PROJECT
PROPOSED RESIDENCE FOR MRS. HIBA AND MR.MOHAMAD SHAKEER AT MANGALORE.

DRAWING TYPE
GFC

DRAWING TITLE
Roof Plan

Dwg no.	211/gfc/02/R5
Date	30-01-2021
Drawn By	Shrey

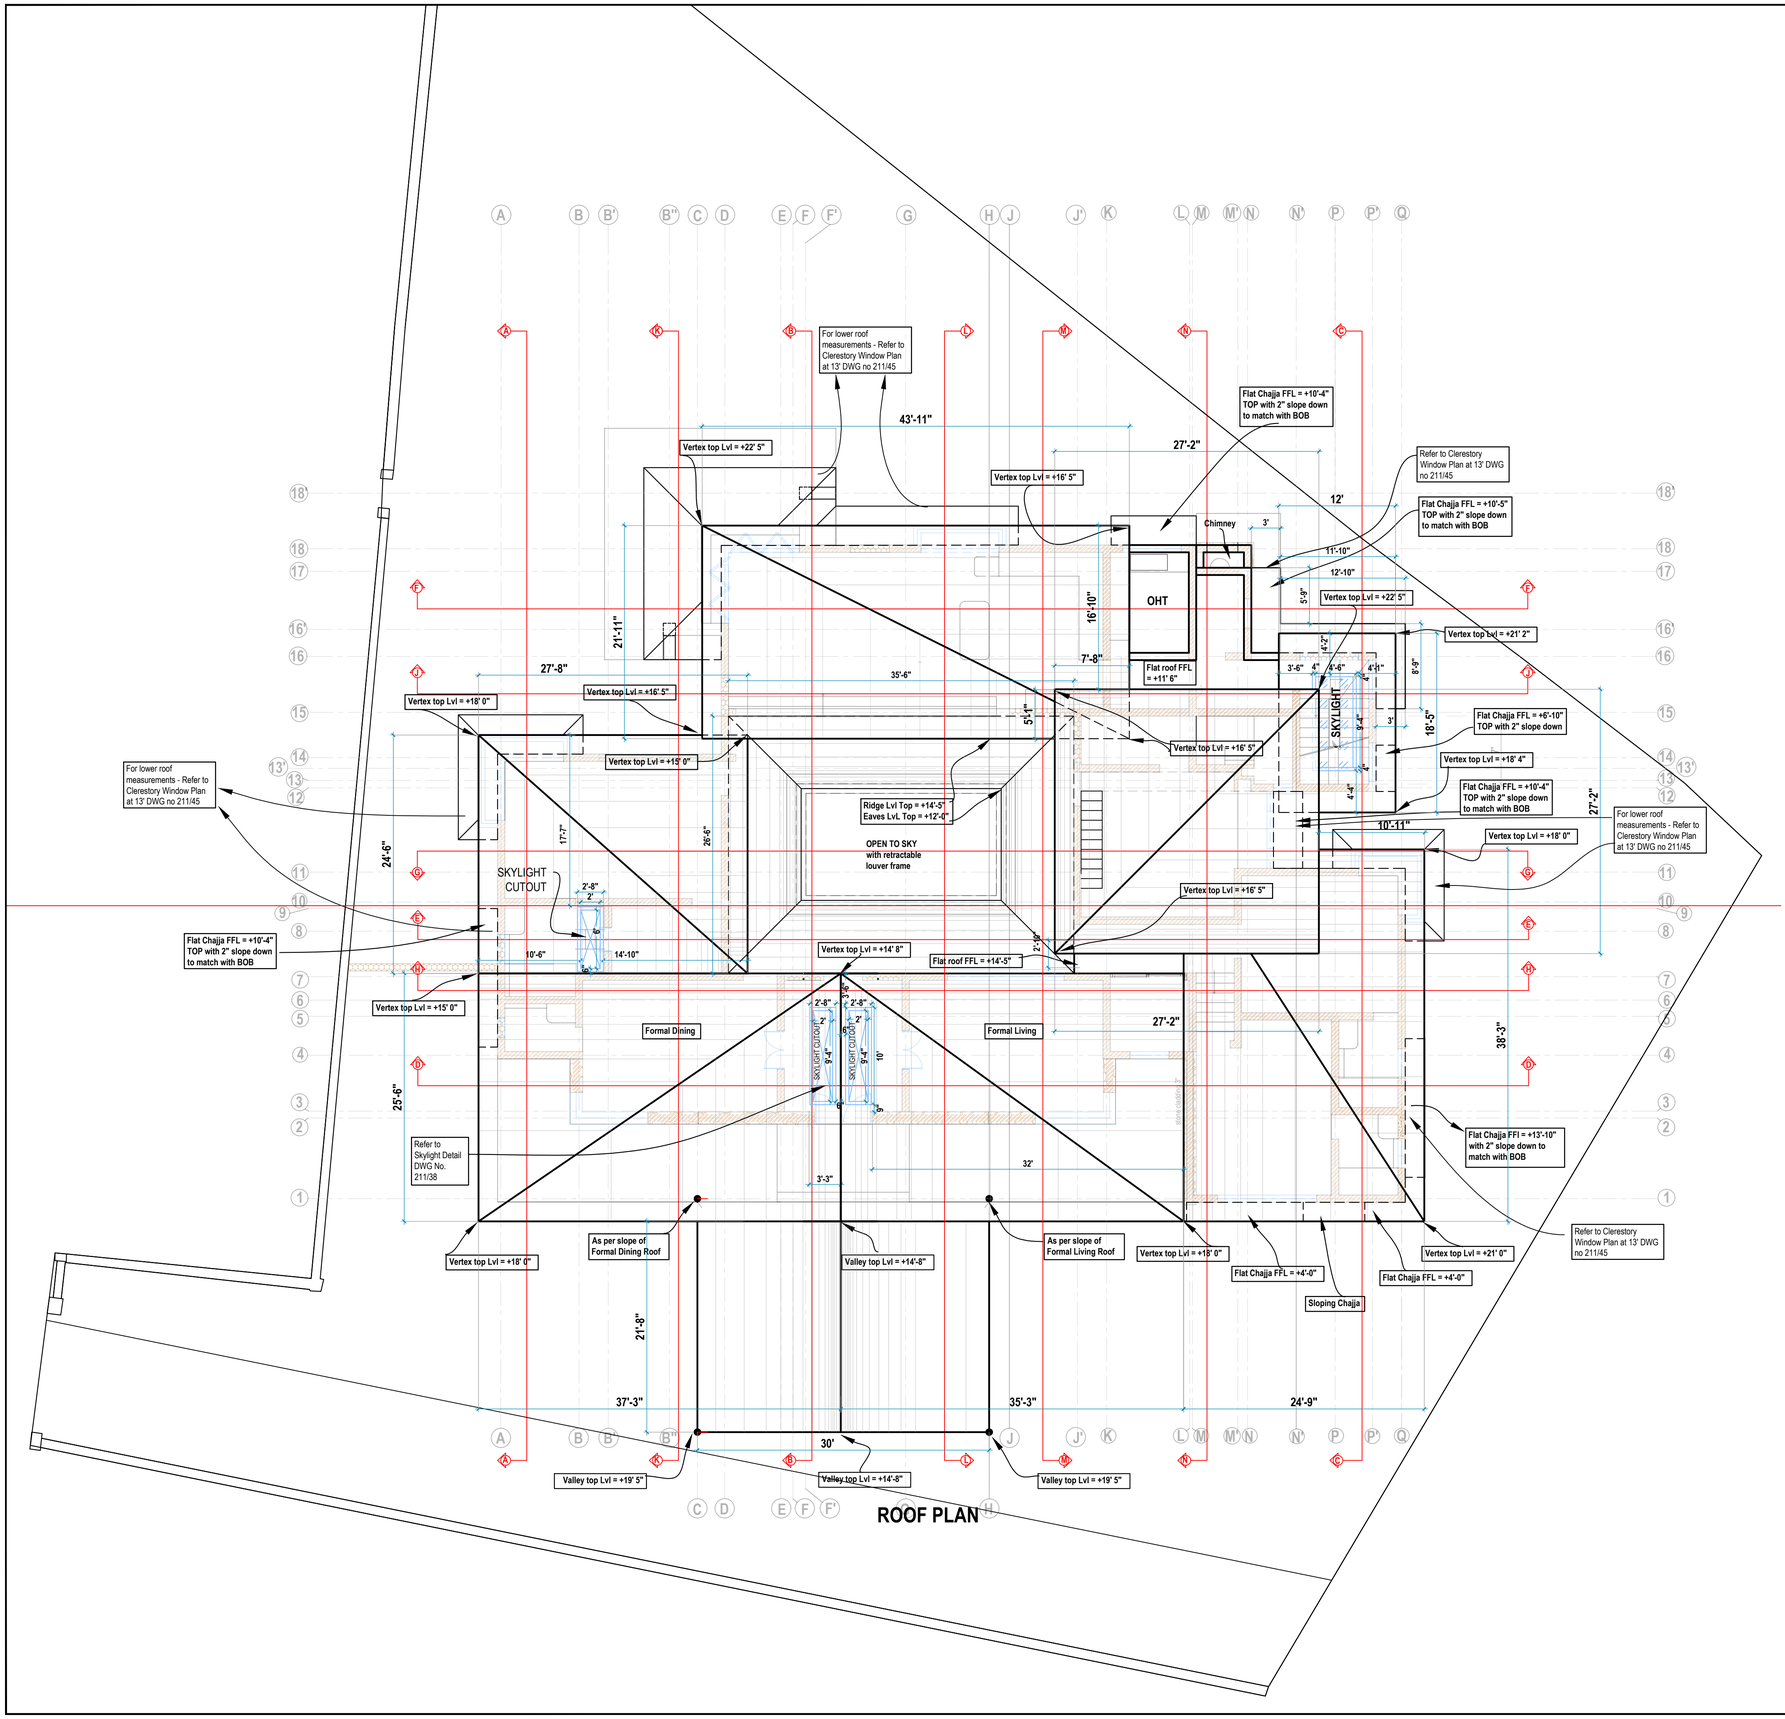
S.NO.	REVISION	DATE
R1	i.Service area roof updated as per changes in plan ii.Courtyard roof extended	17-04-21
R2	i.Sloped roofs of Bay window's top matched till beam top ii.The overhang of 2ft on Northside and Westside and Southside for the formal living roof, keeping the vertex height the same iii.A flat roof extention above the CBR window upto tie beamtop level	26-05-21
R3	Sloped roofs at Formal Living and Formal Dining meet at common edge now Informal Living and CBR Roof Top Vertex corrected to 22'-5" Service Area Sloped Roof added	26-06-21
R4	Change to portico roof	11-08-21
R5	Removal of courtyard passage skylight Revision of foyer skylight	12-10-21
